**RE: 2-6 HASSALL STREET, PARRAMATTA  
NSW EPA – RESPONSE TO REQUEST FOR INFORMATION**

This letter outlines our response to the acoustic queries presented in the NSW EPA's review (DOC19/427685 dated 14/6/19) of the SSDA (SSD9670).

**Figure 1: Subject site and surrounding noise sensitive receivers**

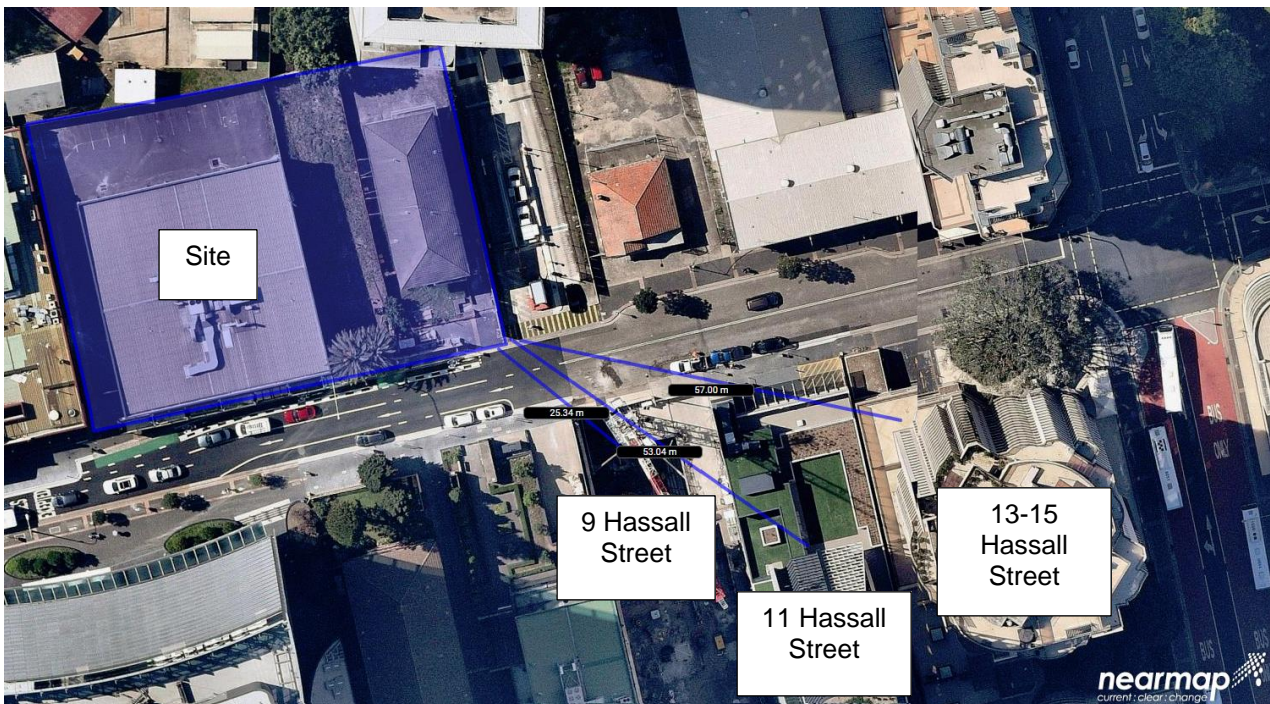
*The NPfI specifies that background noise is measured at the most or potentially most affected noise-sensitive locations. The EPA considers that the background noise monitoring on the western side of the development site was potentially affected by noise from the Commercial Hotel and may not be representative of the nearest affected sensitive receivers.*

We note that these developments are the nearest potentially affected noise sensitive receivers, as referred to in the EPA review. However, the presence of construction activities would result in extraneous background noise levels if noise logging was conducted at these sites as suggested by the EPA.

Nevertheless, in order to establish whether the background noise levels presented as part of the noise impact assessment for 2-6 Hassall Street were representative of the noise levels experienced at the nearest noise sensitive receivers (in the absence of extraneous noise from construction activities), Floth has reviewed the background noise conducted as part of the 11 Hassall Street development application<sup>2</sup> (DA/67/2015).

Given that the noise monitoring conducted in 2018 is within 2 dB of the noise monitoring conducted at the 11 Hassall Street site in 2015, we consider that the background noise levels presented in the noise impact assessment for 2-6 Hassall Street are representative of the noise levels experienced at the nearest noise sensitive receivers and is considered valid. As such, further noise monitoring is not required.
